**RE: Adagio Apartments
Tr A, Cantata at the Trails Unit 2
Conceptual Grading Plan Stamp Date: none (7/19)
Drainage Report Stamp Date: none (7/19)
Hydrology File: C09D014**

Based on the submittal received on 7/19/19, the Conceptual Grading and Drainage Plan cannot be approved until the following corrections are made:

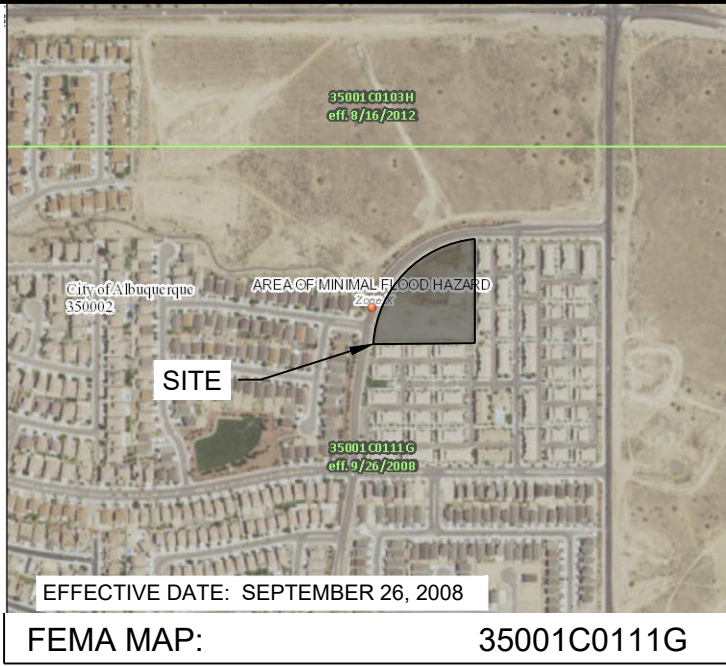
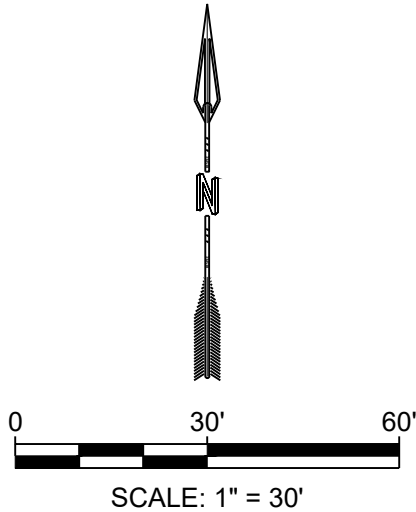
8. Provide one (or several large) central facility for Stormwater Quality volume (SWQV) retention; individual ponds for each apartment unit will not be accepted.

9. Please provide the SWQV calculations for each basin draining to each pond. The stormwater quality ponds need to be sized for the areas draining to them.

11. The site must demonstrate adequate downstream capacity per § 14-5-2-12(G) of the Albuquerque Code of Ordinances. 10 cfs discharge to the storm drain is identified, but how will runoff be controlled?... pond, orifice plate, detention in the drive aisles? The controlling feature needs to be identified and designed.

13. Drainage conveyance for basins 2-4 is questionable. Will these basins actually make it to the drive aisles? If so how? Can you add low points or drain lines for the sidewalks, along with swales? You could also treat these areas as contiguous self-ponding areas, coupled with drainage covenants. This would also enable basin 1 to free discharge.

14. Hydraulic calculations are missing, to include:
 - a. Provide street capacity analysis demonstrating that the 100-year HGL remains at/below top of curb.

- b. Provide inlet calculations, including 2x capacity (50% clogging factor) for inlets in a sump. For orifice calculations, the open area (or void space) for the new bike-friendly Albuquerque grate (Dwg 2220) is 3.72sf. Please ensure you orifice calculations are updated to reflect this.

- c. Provide hydraulic calculations for this proposed storm drain system, calculated along the Energy Grade Line; include both the HGL and EGLs in the table.

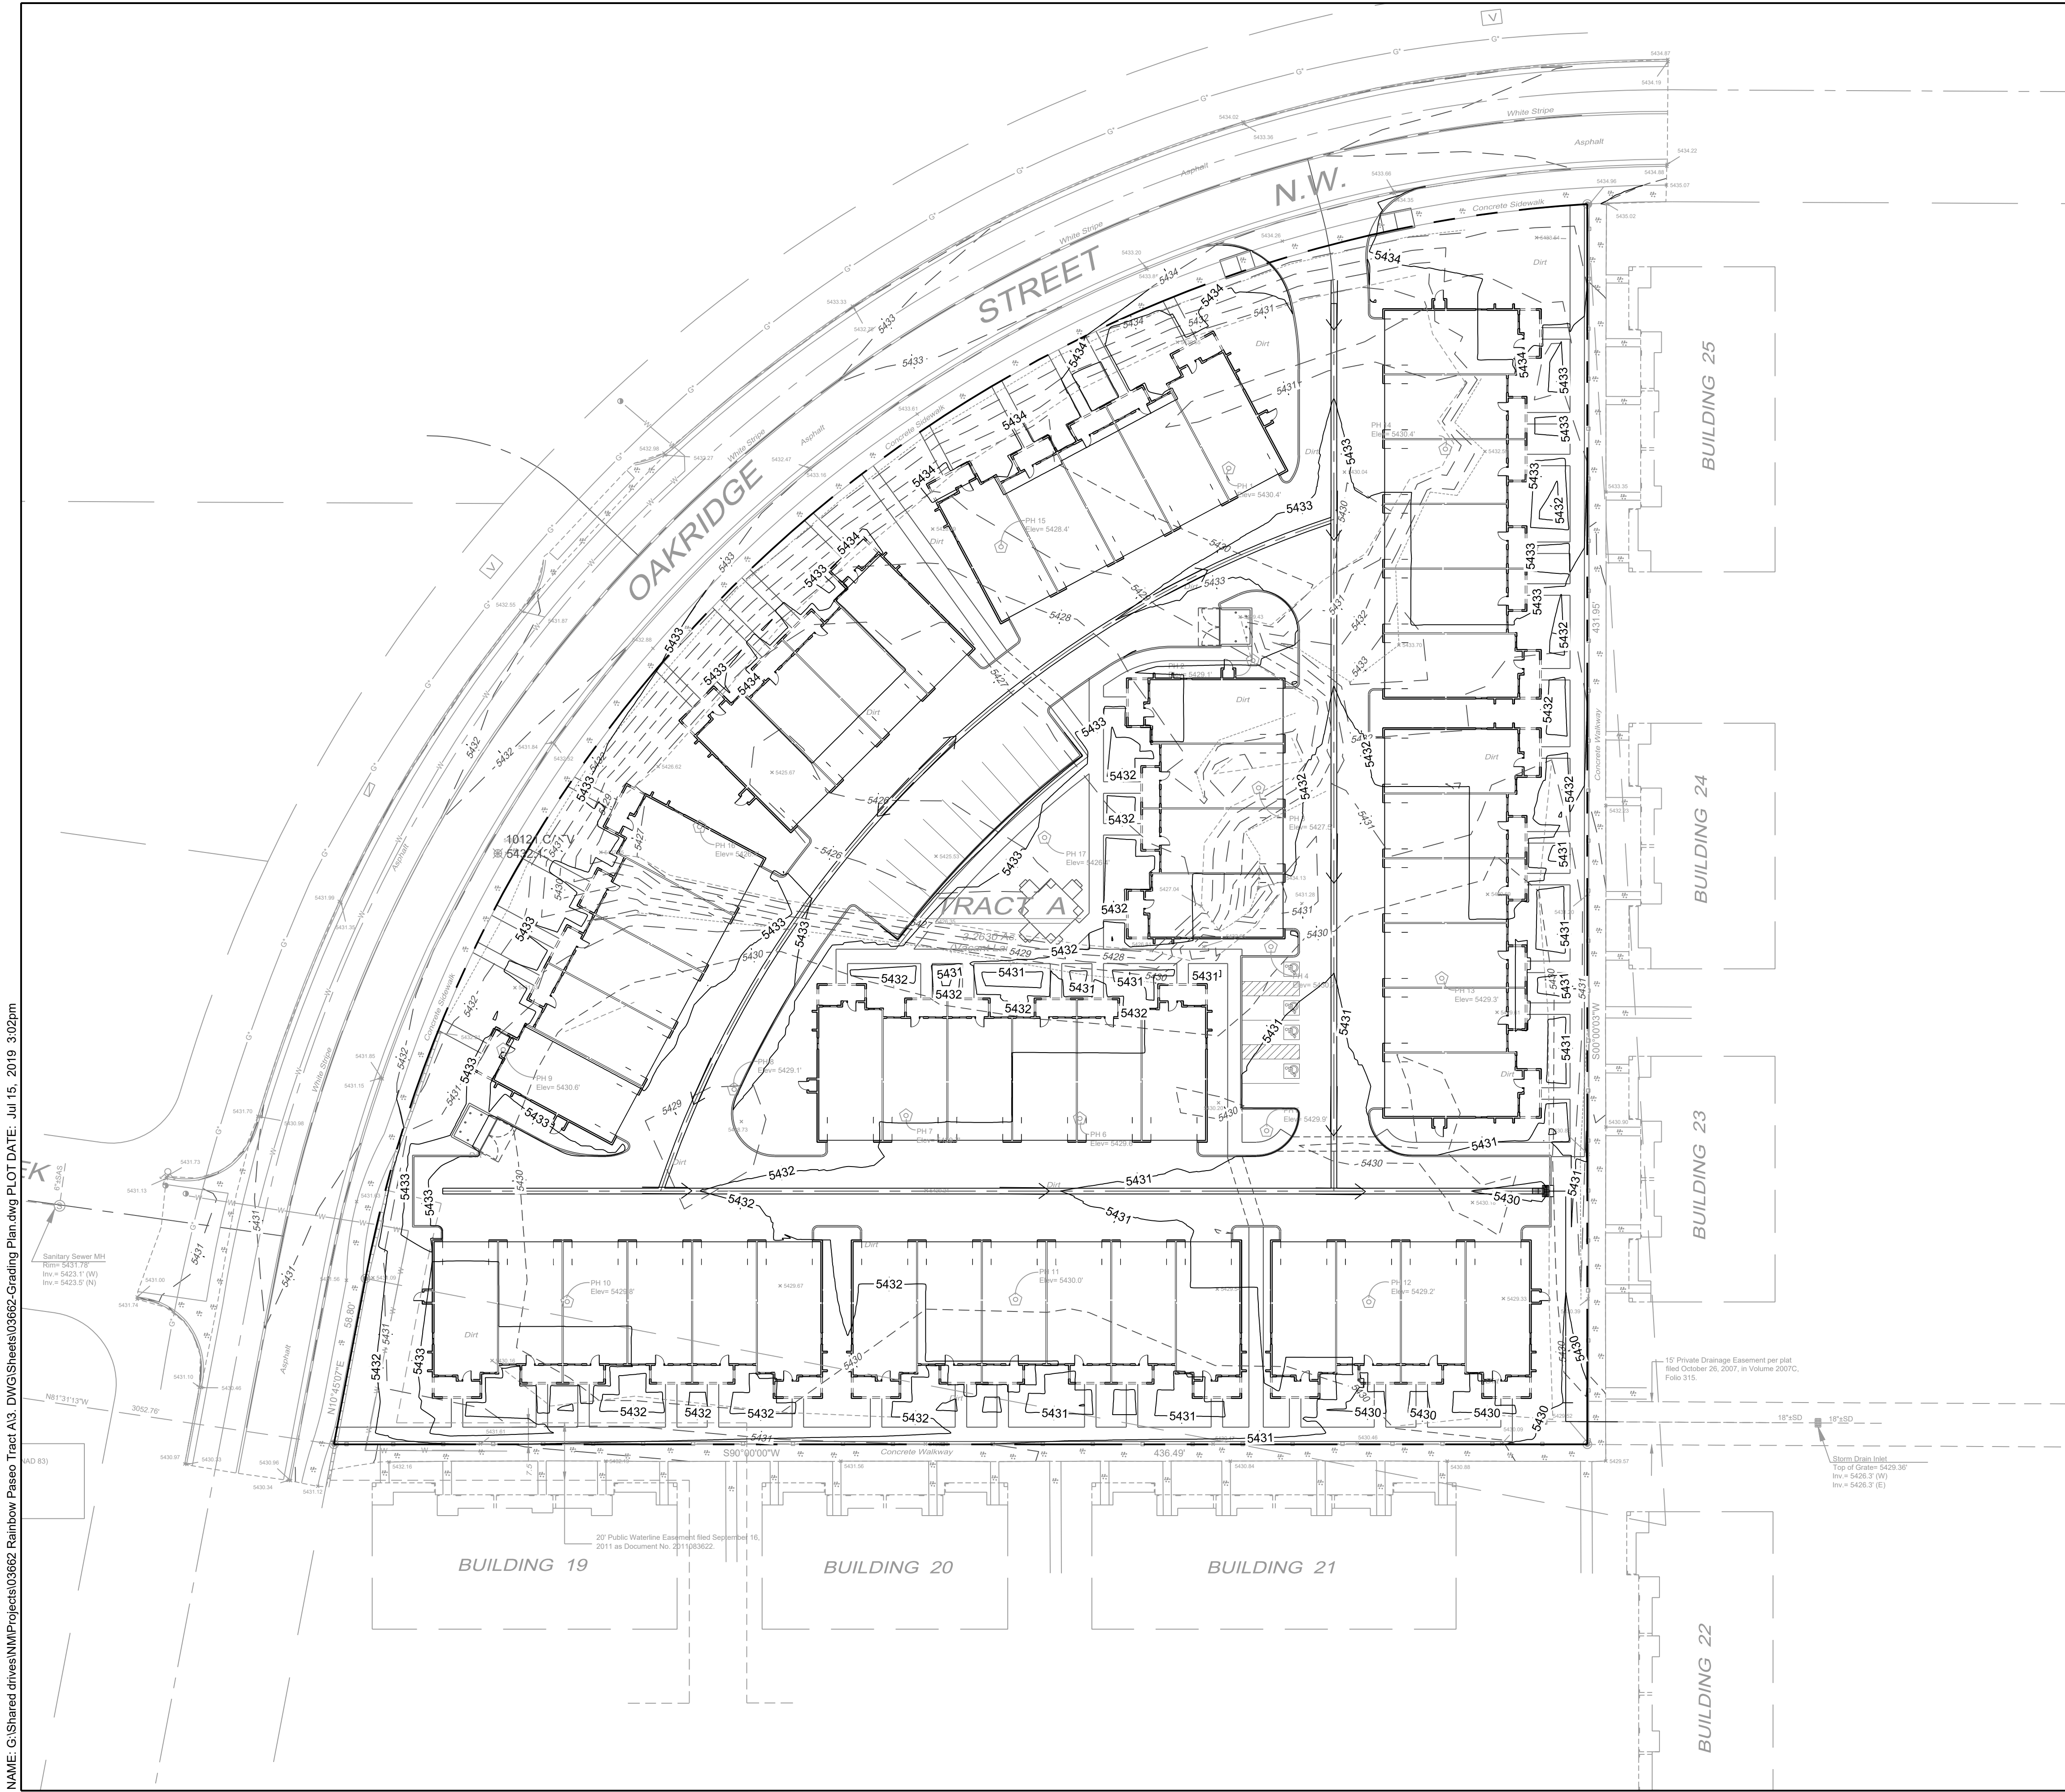
1. Please provide an engineer's stamp with a signature and date on the plan and use the [current DTIS version](#) (11/2018) when resubmitting.

2. Identify all existing drainage easements on the plan, as well as any proposed easements, vacations, and lot line adjustments.

3. Identify all drainage infrastructure as private vs. public.

4. Include project benchmark and datum.

6. Please provide a vicinity map showing the location of the site. Typically this is the Zone Atlas. This can be downloaded in pdf format from the City of Albuquerque's website.

10. Please show and label the pond(s) and include a label on each with the SWQV and elevation, the 100-year volume and elevation, the peak 100 year inflow and outflow, the spillway crest elevation, and the spillway flow depth.

- d. Pond routing as necessary.
15. A waterblock, 0.87' high, per COA Paving Detail No. 2426, is required at the driveway entrance.
